Appendix 1: Objection to Refused Planning Application 2024/3123/P

Planning Application (LPA reference: 2024/3123/P) proposing the 'Erection of single-storey roof extension to provide 2 new residential (Class C3) units' at: Glebe House, 15 Fitzroy Mews, London, W1T 6DP.

DLP Planning have been instructed by the leaseholders of Glebe House to lodge a formal objection to Planning Application 2024/3123/P, submitted by Works Architecture on behalf of John Broomfield. The Application seeks permission for the: *'Erection of an additional storey to create 2 residential dwellings.'*

Figure 3: Dwg No. e-100, with two red lines inserted to compare the height of neighbouring buildings.

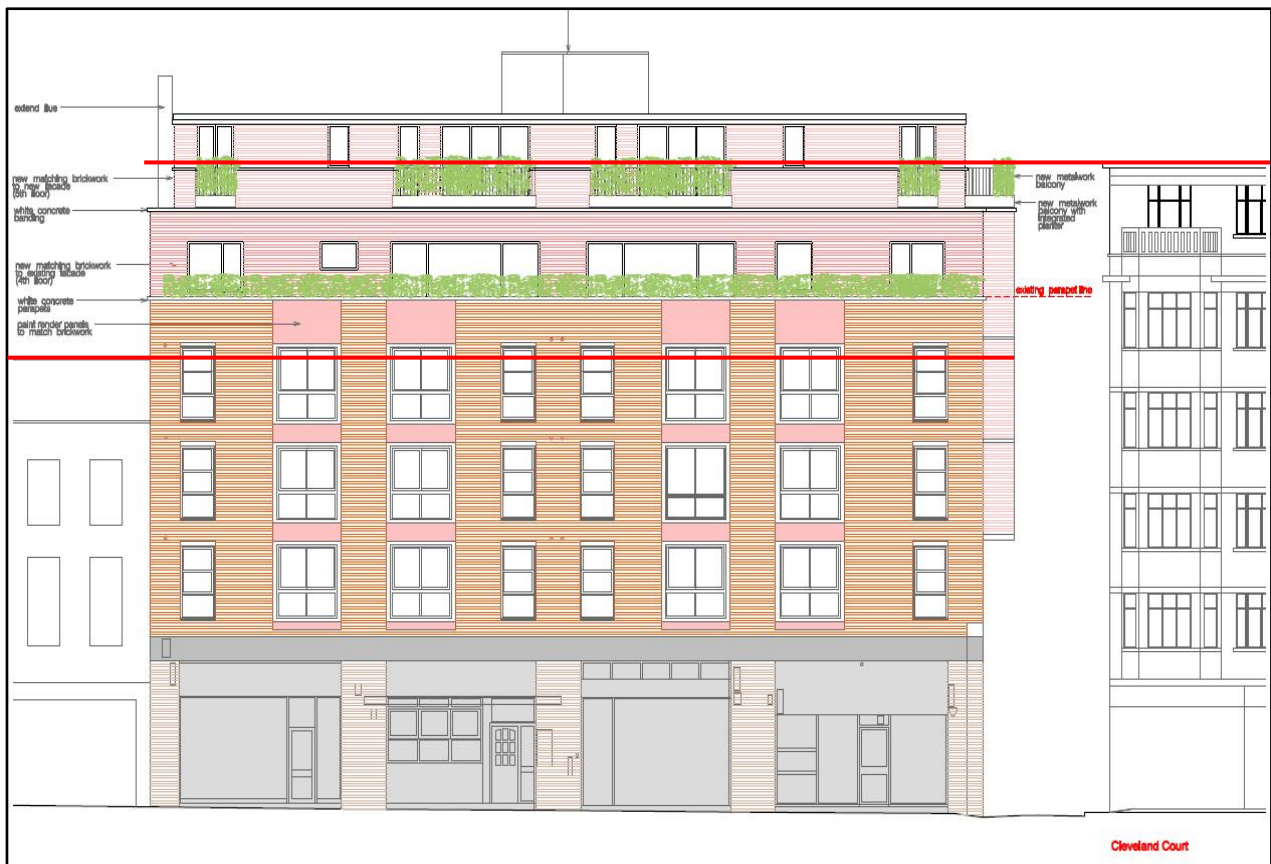
Drawing No. e-100 (Figure 3), shows the proposed front elevation of Glebe House which fronts Cleveland Street and includes the adjacent/adjoining terraces located directly north and south. Annotations have been inserted to indicate the height of these existing buildings in contrast to Glebe House after the proposed works have been completed. It is clear that the additional storey would result in an overly dominant building with no positive relationship with nearby buildings, particularly the adjoining terrace to the north (100-126 Cleveland Street).

By not providing dimensions on the submitted plans, the Applicant has made it difficult for the Local Planning Authority and members of the public with an interest in the proposal, to accurately understand the scale of the development. This is further exacerbated by the Applicants failure to acknowledge the difference in site levels between Fitzroy Mews to the east and Cleveland St to the west. No topographic survey was included in the planning application nor have site levels been included in the submitted plans.

Figure 4: Dwg No. e-103, with a red line inserted to show the difference in height between 4-7 Fitzroy Mews and Glebe House.

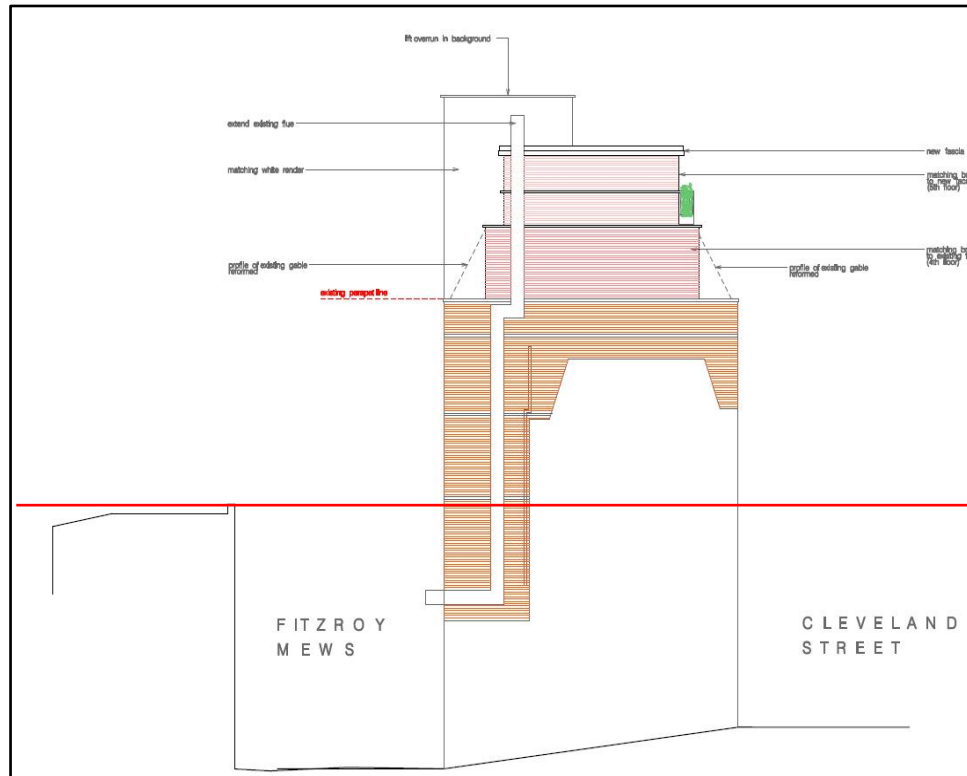
Notwithstanding, measurements of the submitted plans using the scales provided, indicates that there is an approximate 1.8 m difference between the two frontages, therefore the units located directly opposite Glebe House within the Mews (4 – 7 Fitzroy Mews) sit considerably lower than the Glebe House. The mews have an overall height of 8.5 m, should the proposal be approved, the eastern elevation of Glebe House would measure to be 22 m in height from Fitzroy Mews and dominate over 4-7 Fitzroy Mews by approximately 13.5 m as shown in Figure 4 below.
